SUPPLEMENTAL INFORMATION PERTAINING TO THE ECCS REEVALUATION

December 30, 1976
L-76-439

Re: Turkey Point Units 3 and 4
Docket Nos. 50-250 and 50-251
ECCS Reevaluation
Supplemental Information

Figure 1a. Fluid Quality — DECLG ($C_D = 1.0$)

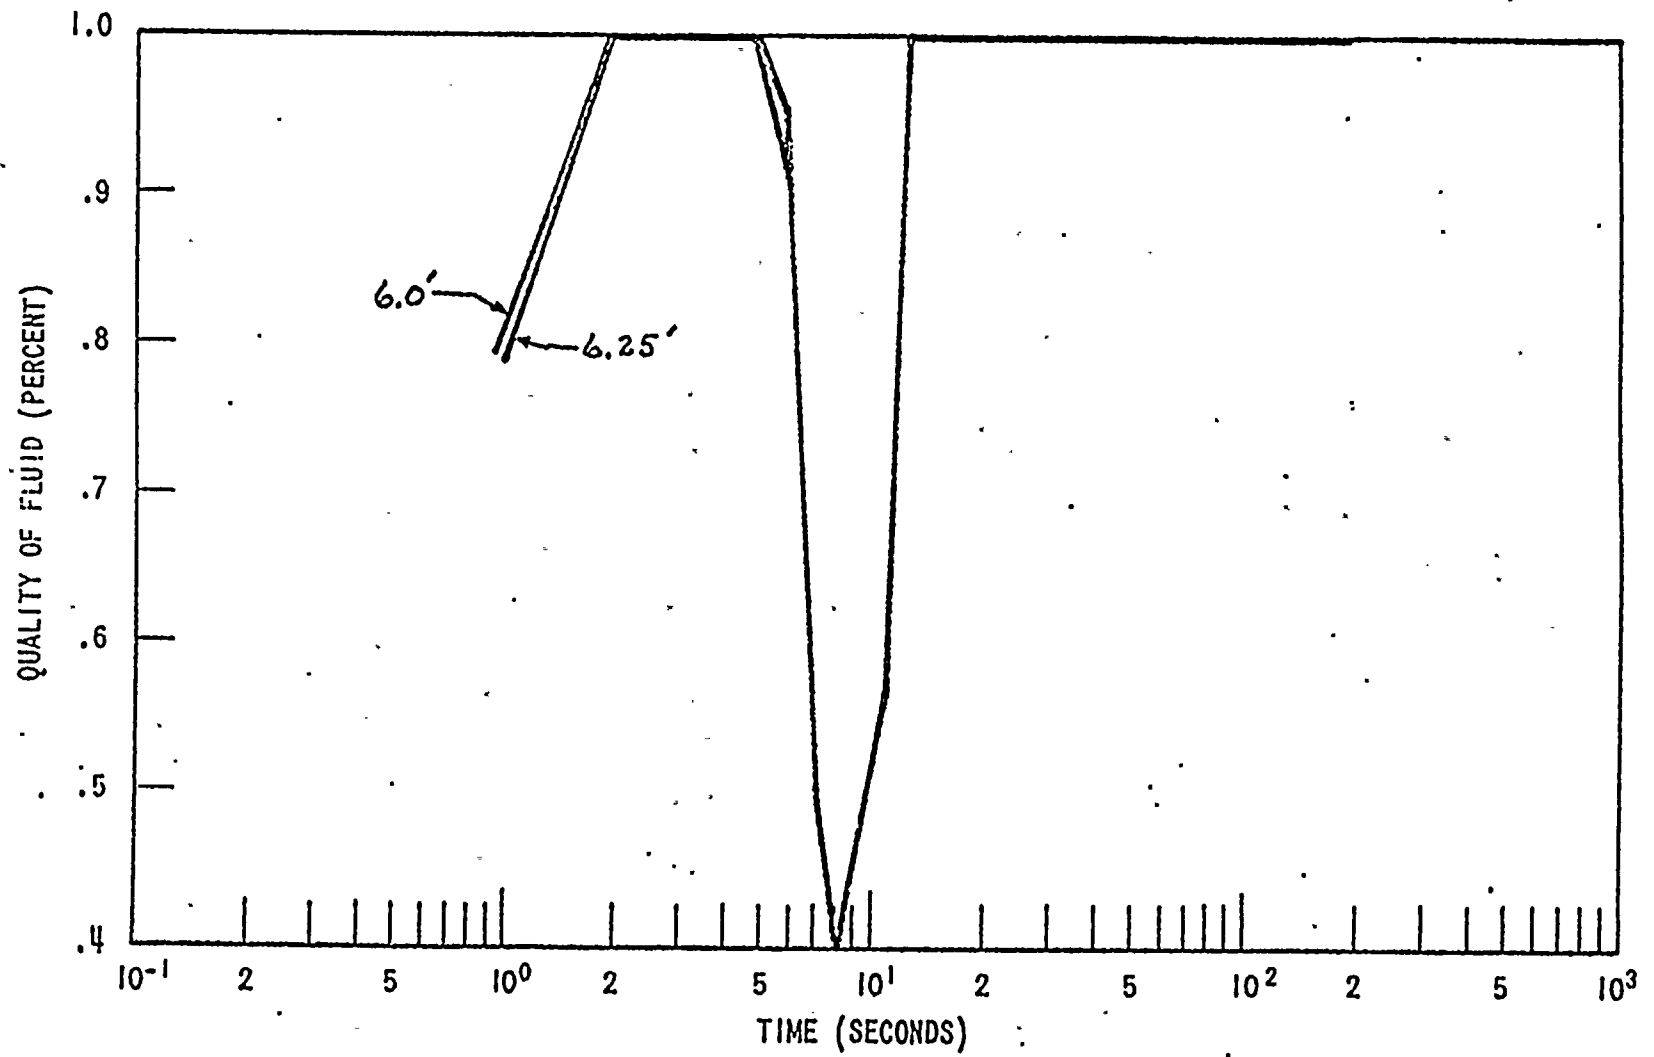
QUESTION - Show which of the curves in Figures 1a through 8d correspond to hot spot location and which to clad burst location (most of the curves are unlabeled).

ANSWER - Figures 1a through 4d and 7a through 8d have been labeled so that comparison with Table 2 will show which curves correspond to hot spot location and which to clad burst location. The labeled curves are attached:
